DEVELOPMENT REVIEW BOARD REPORT

CASE NUMBER/ PROJECT NAME	91-DR-2005 SEC Scottsdale & Lone Mountain		
LOCATION	31313 N. Scottsdale Road		
REQUEST	Request approval of a site plan and elevations for a new retail center..		
OWNER	Optima I Investments LLC 949-725-3060	ENGINEER	CMX Group, Inc. 602-567-1900
ARCHITECT/ DESIGNER	Ellermann & Schick, Inc. 602-266-6202	APPLICANT/ COORDINATOR	Gary Pederson Pederson Group, Inc 602-265-2888

**Project Narrative
Development Review Board Approval
SEC Scottsdale Road and Lone Mountain Road
Case No. 623-PA-2005**

ATTACHMENT #4

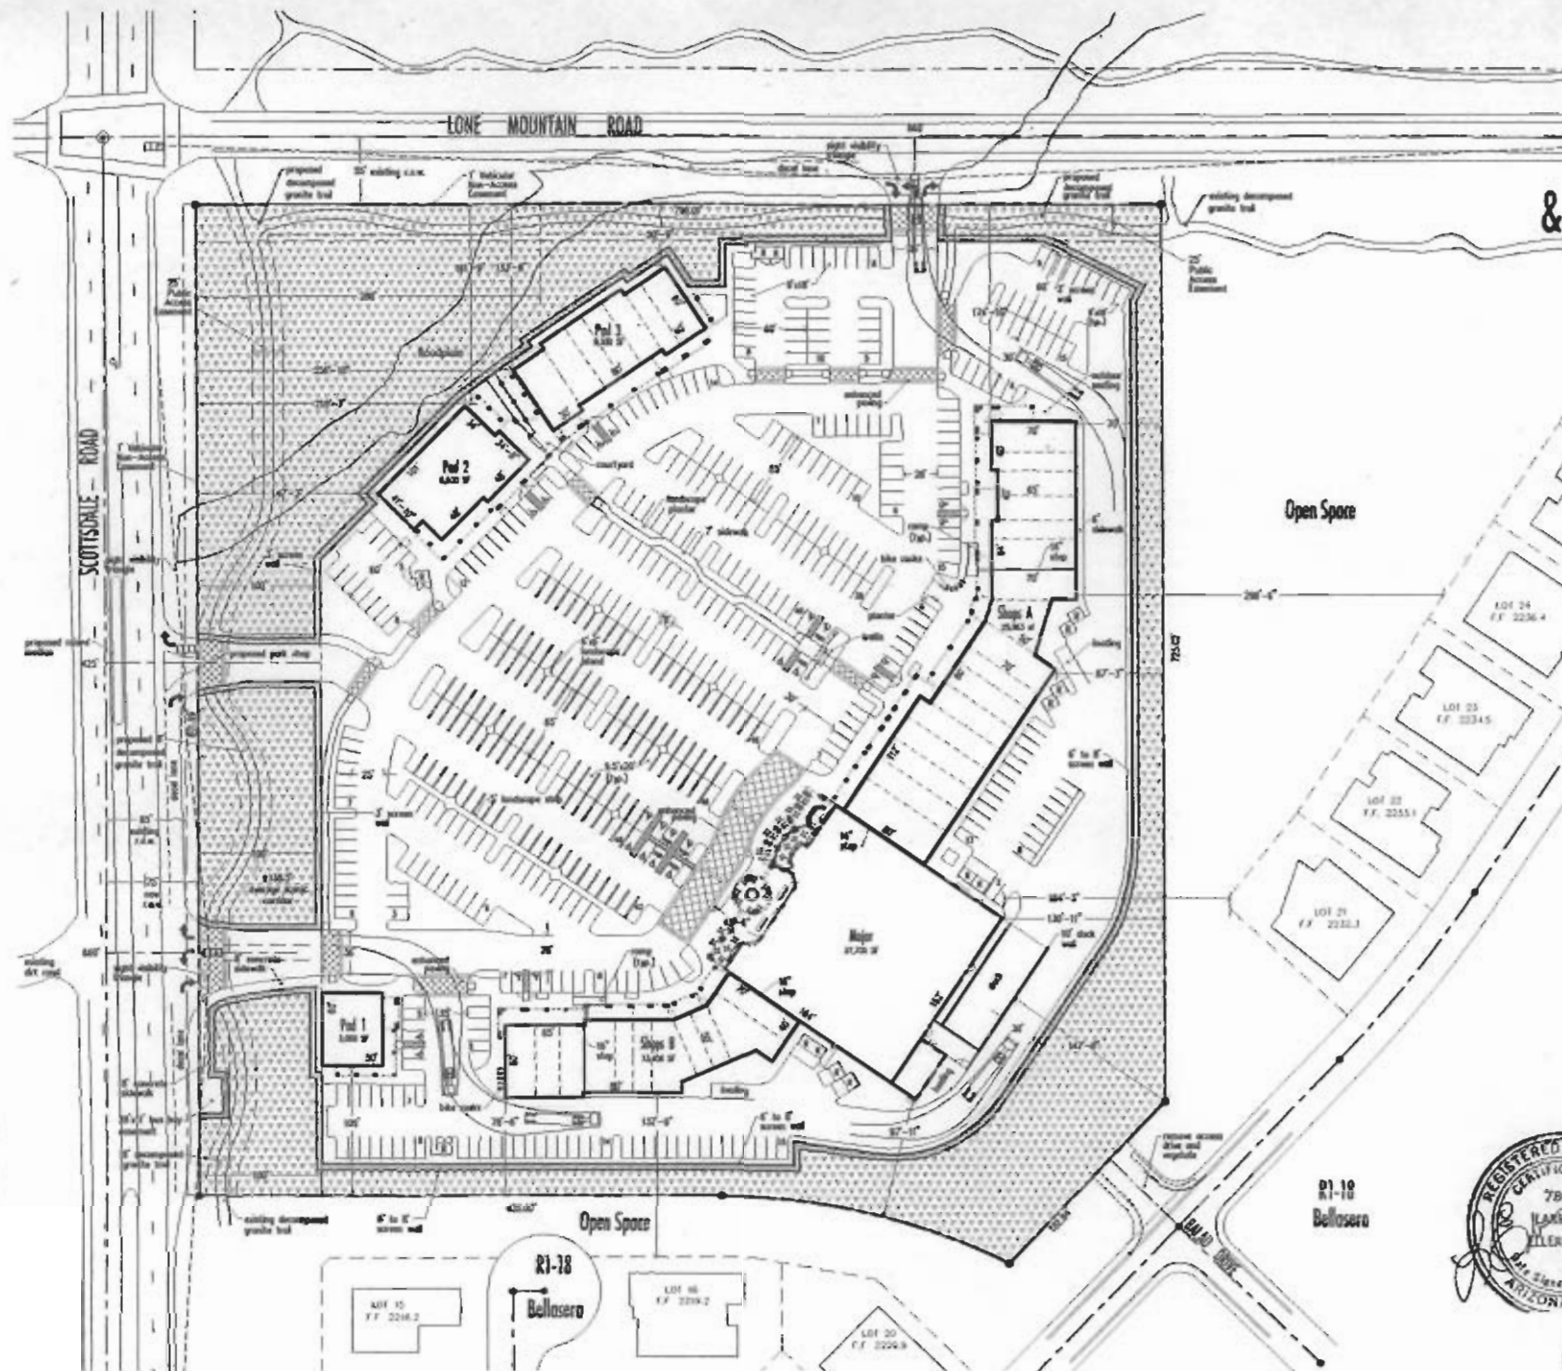
- b. The location and configuration of all site improvements shall be constructed to be consistent with the site plan submitted by Ellerman, Schick, & Bruno with a staff receipt date of 6/2/06.

11. *The site plan shall be revised to call out the locations of all proposed electrical transformers. No transformers shall be located within designated NAOS easements, or within the limits of the Scenic Corridor on Scottsdale Road.*
